**CLARKE COUNTY PLANNING COMMISSION
TABLE OF CONTENTS
August 29, 2017 Briefing Meeting
September 1, 2017 Regular Meeting**

**SPECIAL USE PERMIT/SITE PLAN (SUP-17-03/SP-17-01)
Clarke County Board of Supervisors (Citizens' Convenience Center)
September 1, 2017 Planning Commission Meeting –PUBLIC HEARING
STAFF REPORT– Department of Planning**

CLARKE COUNTY CITIZEN CONVENIENCE CENTER CLARKE COUNTY, VIRGINIA

SHEET NO.
KARST

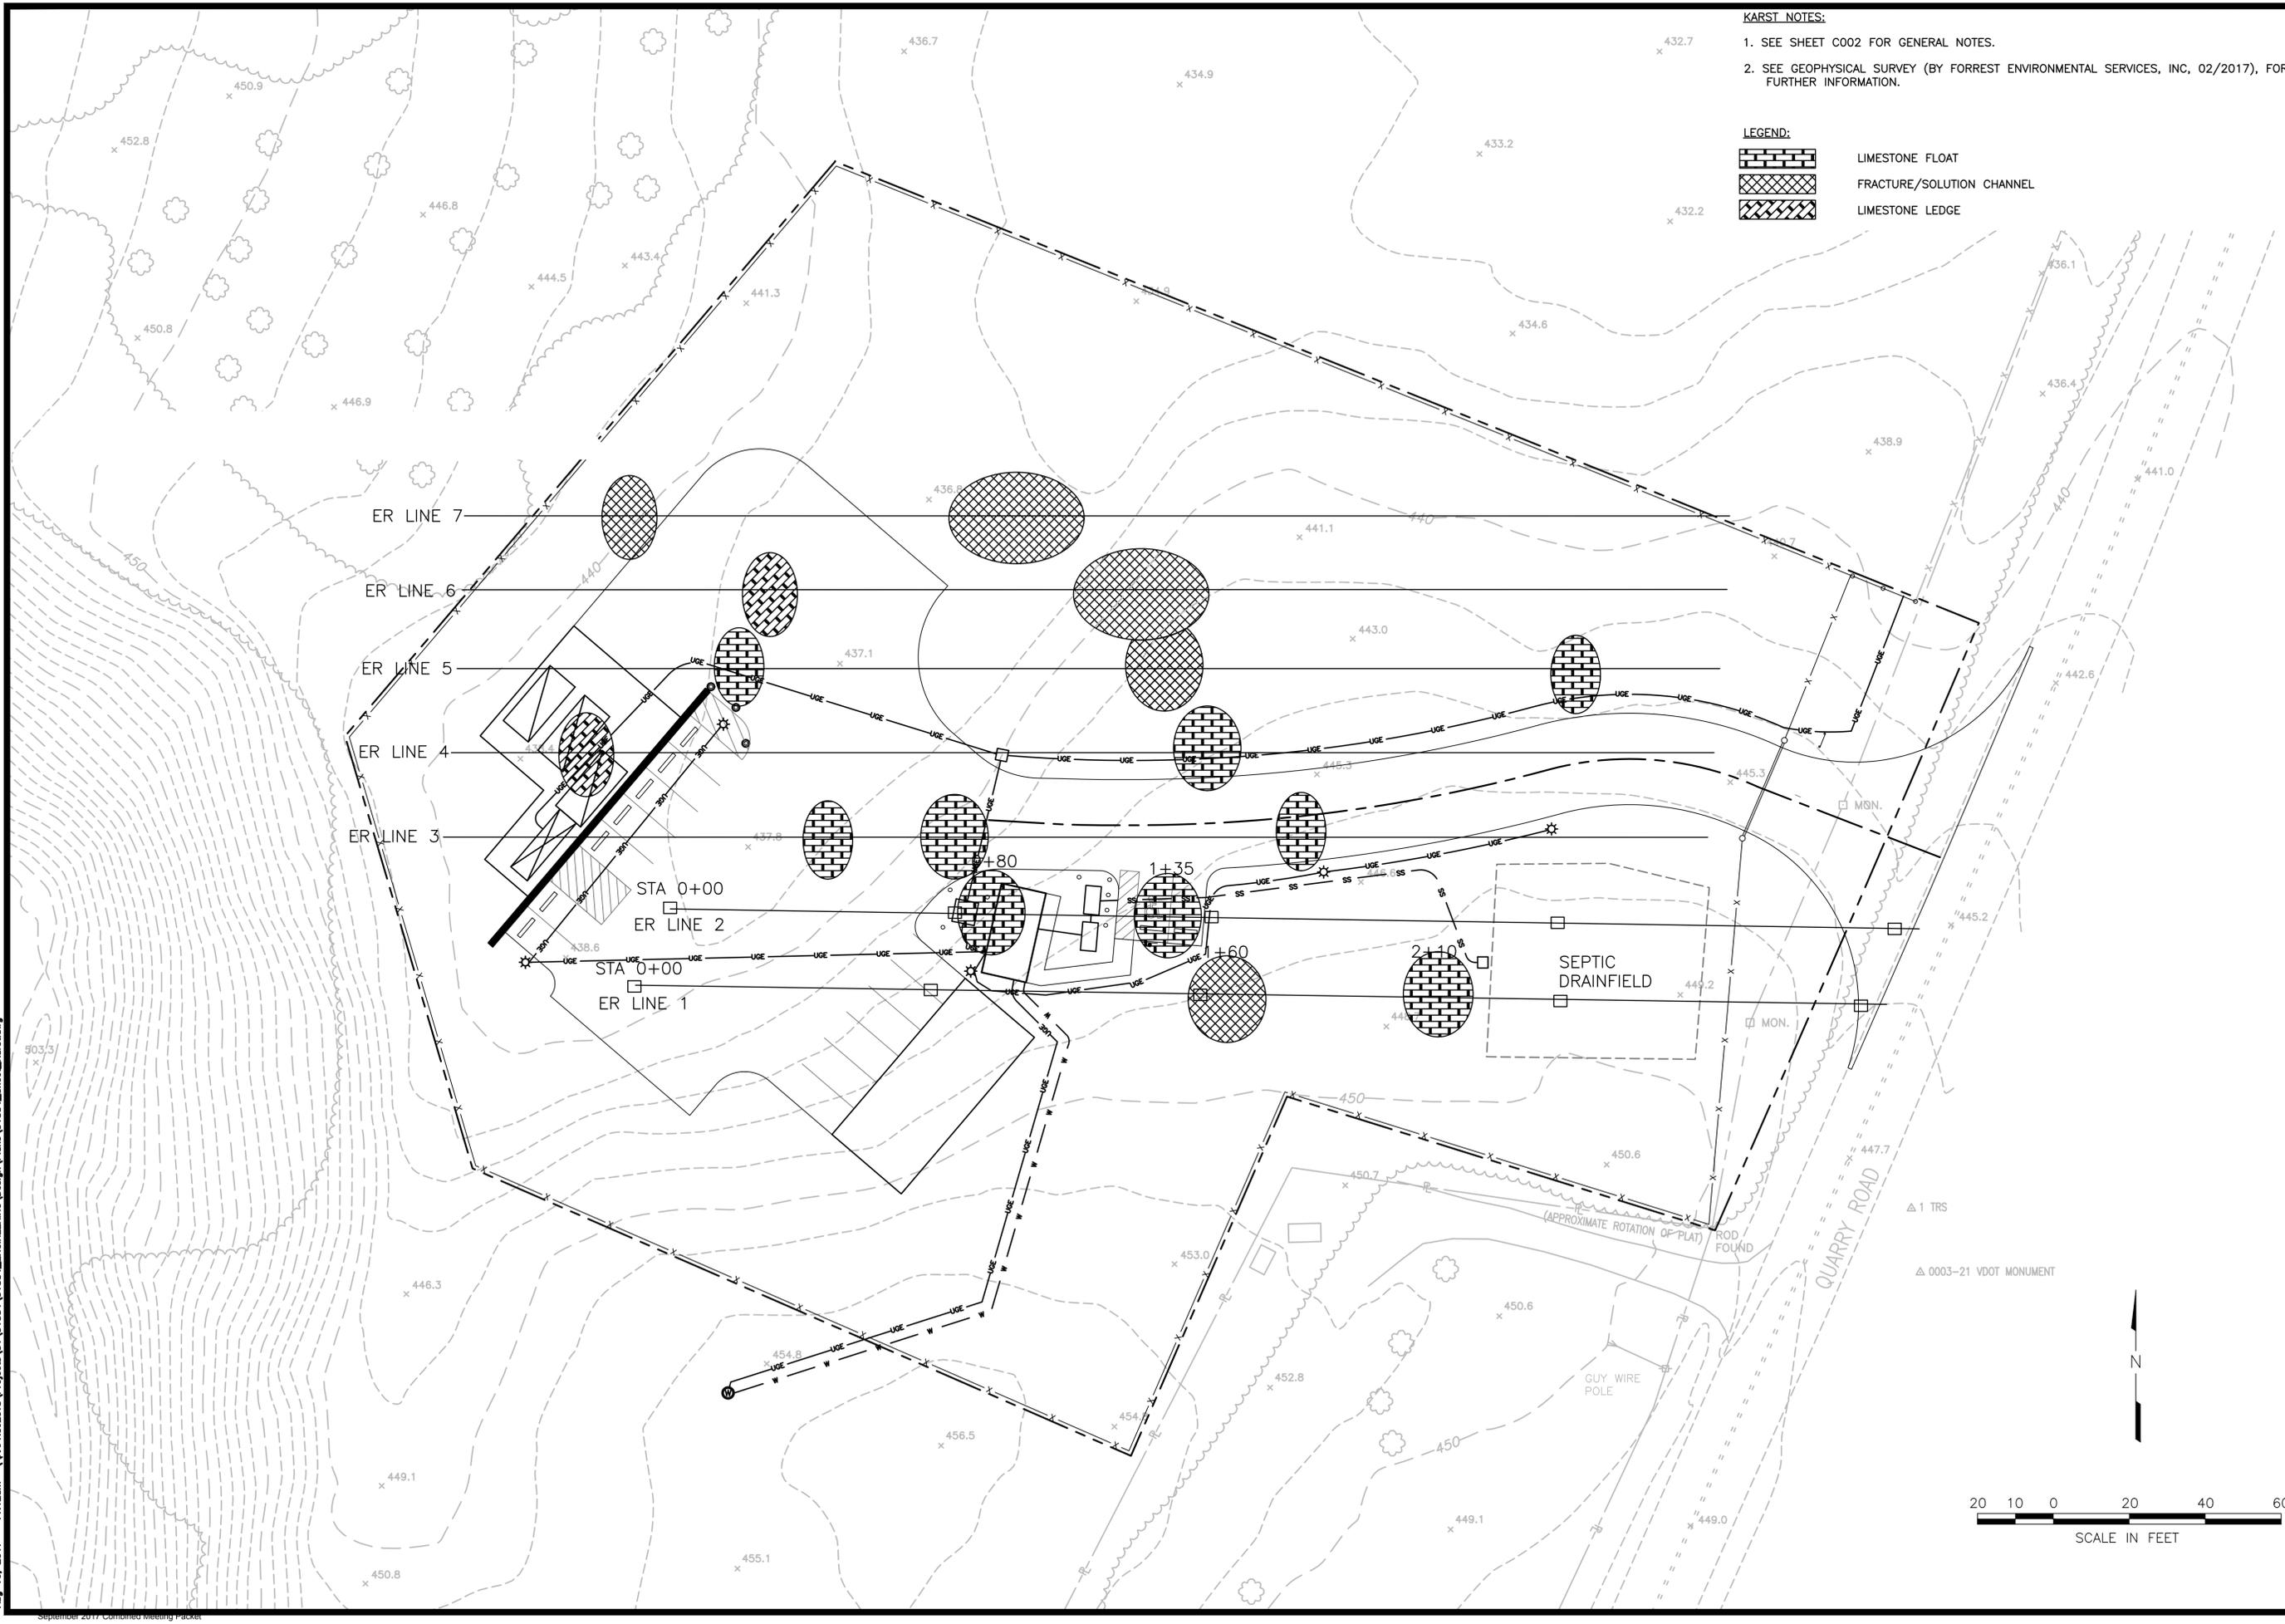
The geotechnical study conducted by Forrest Environmental for the proposed sewage disposal area which also extended toward the compactor area was used by the Applicant's engineer to prepare a preliminary karst plan sheet. The applicant's engineering firm geotechnical specialist recommended additional testing, which was also performed by Forrest Environmental and submitted on June 21, 2017, and it notes that more review may be necessary. Dan Rom (Piedmont Geotechnical) has been routed the first two reviews and will offer comments when the applicant's engineer has satisfied their own geotechnical staff.
